HOW TO IDENTIFY VAG GROUP STEERING RACKS ERRM1108, ERRM1109, ERRM1110

VAG OE Generation Steering Racks

STEC.10028 18/07/22

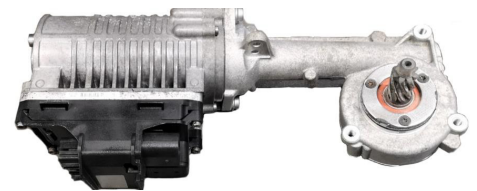
The OE Generation 1 and 2 steering Racks have been discontinued by the OEM. This leaves the latest OE numbers which are for the Generation 3 steering rack only

The latest number will cross reference to ERRM1110. This could be incorrect for pre 2009 vehicles.

Generation	Date From	Date To	Number of Rack Mounting Holes
1 (ERRM1108)	2003	2004	4
2 (ERRM1109)	2004	2009	4
3 (ERRM1110)	2009	Onwards	3

In order to retrofit the generation 3 steering rack to an earlier vehicle, please observe the following information:

1. Should your vehicle be fitted with a Generation 1 steering rack, you will have to update:

- Wiring Harness
- Subframe

2. If you have a generation 2 steering rack, you will have to update:

- Wiring harness

3. For replacing generation 3 steering rack, no further parts must be replaced.
